Re: Revised Vapor Intrusion Assessment Work Plan  
Atlantic Richfield Company Service Station #2035  
1001 San Pablo Avenue, Albany, California  
ACEH Case #RO00000100

**REVISED**  
**VAPOR INTRUSION ASSESSMENT WORK PLAN**  
Atlantic Richfield Company Station #2035  
1001 San Pablo Avenue, Albany, California  
ACEH Case No. RO0000100

**REVISED VAPOR INTRUSION ASSESSMENT WORK PLAN**  
**Atlantic Richfield Company Station #2035**  
**1001 San Pablo Avenue, Albany, California**  
**ACEH Fuel Leak Case No. RO000100**

- Drawing 1     Site Location Map
- Drawing 2     Site Plan with Proposed Soil-Gas Boring Locations

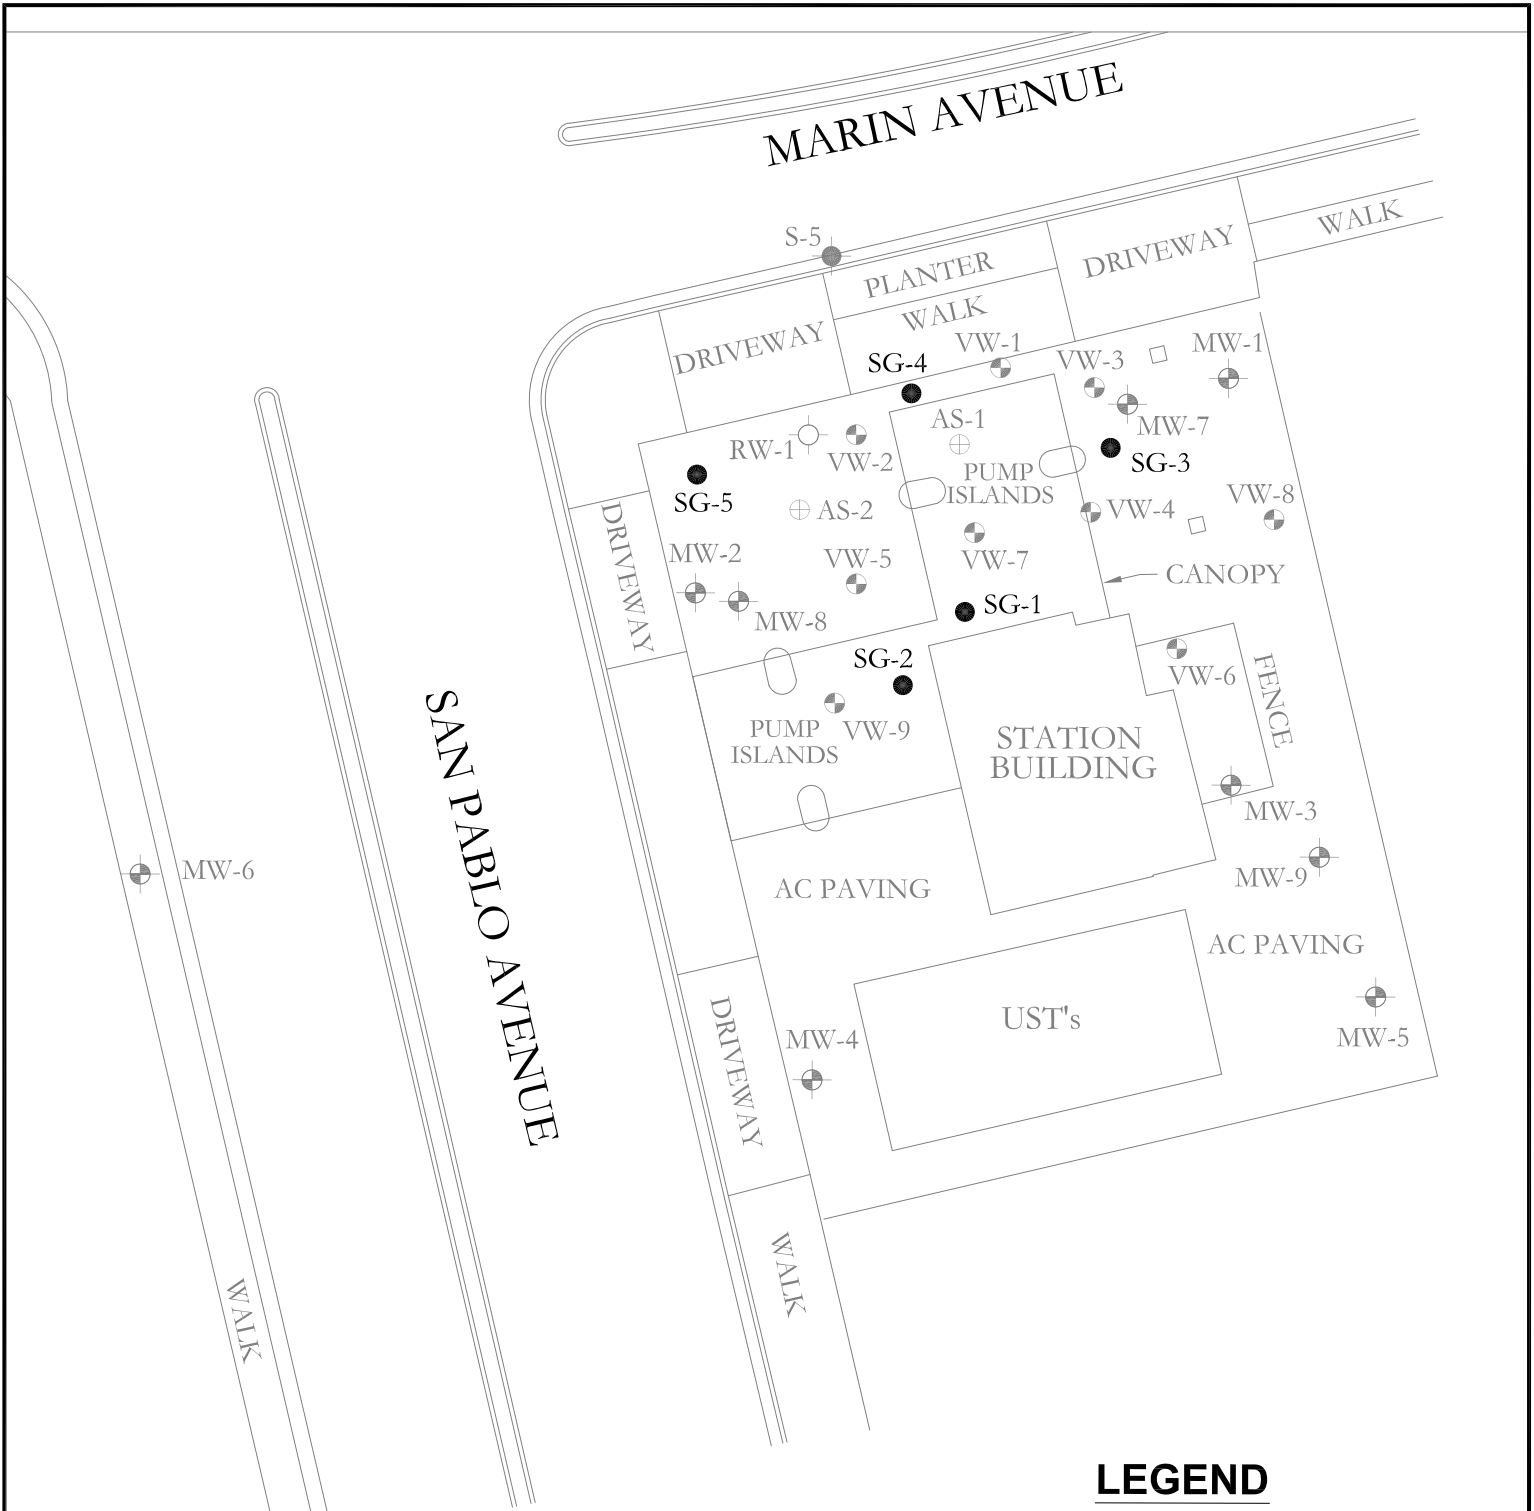
1. **Soil Vapor Sampling Locations** – As mentioned above, BAI proposes to collect three soil vapor samples located on the north, northwest and west sides of the Station Building at the site. Although the proposed sampling locations appear to evaluate potential contaminant volatilization to indoor in the vicinity of the service station building, the proposed locations do not appear to evaluate the entire site, including the north and west sides of the property where elevated hydrocarbon contaminant concentrations in groundwater have been detected at the site. Also, it is important to note that case closure evaluation for the site is based on not only the current land use scenario, but future land use as well. Therefore, it is conceivable that a commercial structure could be constructed over areas of elevated residual hydrocarbons at the site, which were not adequately characterized. To adequately characterize the site, additional soil vapor sampling locations in the areas of likely impact appear justified. Please include additional vapor sampling points in the down-gradient vicinity of monitoring wells S-5, MW-7, and MW-8. Also, please submit a revised site figure that identifies the additional sampling points, due by the date specified below.

As stated previously, Mr. Paresh Khatri's letter from ACEH dated 3 September 2009 requested vapor intrusion assessment not only for the current land use scenario, but future land use as well thinking it would be conceivable that a commercial structure could be constructed over other areas of elevated residual hydrocarbons at the Site. To that end, Mr. Khatri requested additional soil vapor sampling locations in the down-gradient vicinity of monitoring wells S-5, MW-7 and MW-8. In response, BAI has prepared this revised work plan identifying revised soil gas sampling locations. New soil gas sampling location SG-1 is proposed to be located approximately five feet north and eight feet east of the northwest corner of the Station Building. New soil gas sampling location SG-2 is proposed to be located approximately five feet west and eight feet south of the northwest corner of the Station Building. New soil gas sampling location SG-3 is proposed to be located approximately five feet east of the northeastern most dispenser, approximately midway or nine feet from MW-7 and VW-4. New soil gas sampling location SG-4 is proposed to be located approximately one foot south of the northern property boundary, 15 feet west of well VW-1, 10 feet northwest of well AS-1, and 10 feet northeast of well VW-2. Finally, new soil gas sampling location SG-5 is proposed to be located in the northwest corner of the property, approximately five feet from the base of the Station sign. These new locations balance meeting the objectives described in the ACEH letters with creating appreciable distances from existing wells that might otherwise allow short-circuiting of soil gas as well as appreciable distances from known underground structures. Still, the presence of known and unknown underground structures may require the slight relocation of these proposed soil gas boring locations in the field. The proposed soil gas boring/temporary vapor well sampling locations are presented in Drawing 2.
